REFERENCE:	TSB: 08-181-23 GROUP 08 - Electrical	Date:	July 26, 2023	REVISION:	-
VEHICLES AFFECTED:	<p>2021 (DT) RAM 1500 Pickup 2021 (DJ) RAM 2500 Pickup 2021 (D2) RAM 3500 Pickup 2021 (DD) RAM 3500 Cab Chassis 2021 (DF) RAM 3500 10K Lb. Cab Chassis 2021 (DP) RAM 4500/5500 Cab Chassis 2021 (WK) Jeep Grand Cherokee 2021 (MP) Jeep Compass 2021 (JL) Jeep Wrangler 2021 (JT) Jeep Gladiator 2021 - 2023 (DS) RAM 1500 Pickup 2021 - 2023 (LA) Dodge Challenger 2021 - 2023 (LD) Dodge Charger 2021 - 2023 (LX) Chrysler 300 2021 - 2023 (BV) Jeep Renegade 2021 - 2023 (KL) Jeep Cherokee</p> <p>This bulletin applies to DS vehicles built on or before March 06, 2023 (MDH 0306XX) equipped with one of the following radios below: This bulletin applies to JL and JT vehicles built on or before November 22, 2022 (MDH 1122XX) equipped with one of the following radios below: This bulletin applies to KL vehicles built on or before November 14, 2022 (MDH 1114XX) equipped with one of the following radios below: This bulletin applies to LA, LD and LX vehicles built on or before March 29, 2023 (MDH 0329XX) equipped with one of the following radios below: This bulletin applies to BV vehicles built on or before Jan

Fig. 3
Update In Progress Screen

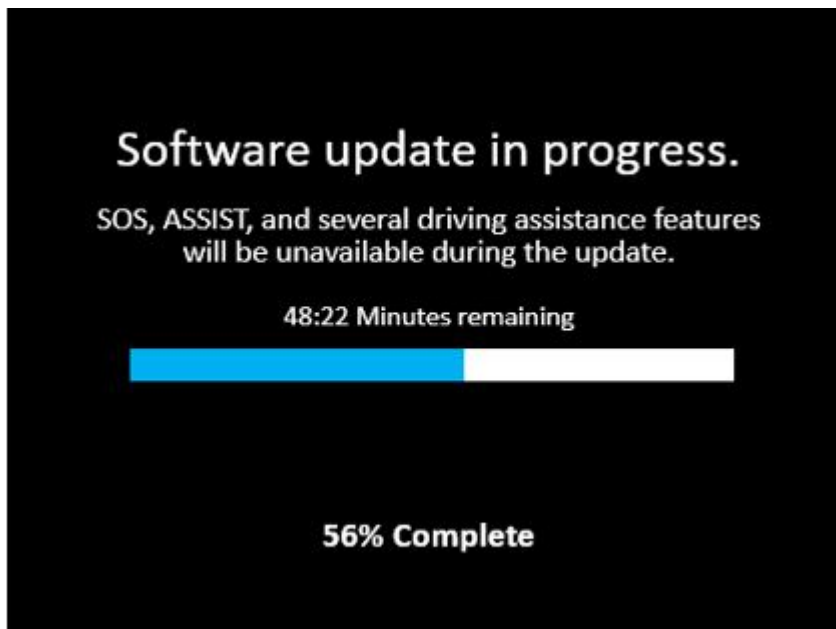
- Whether the customer selects “Update Now”, or “Schedule Update” (Fig. 1) and sets a time, they can shut off the vehicle and leave. The update will be completed automatically (Fig. 3) .
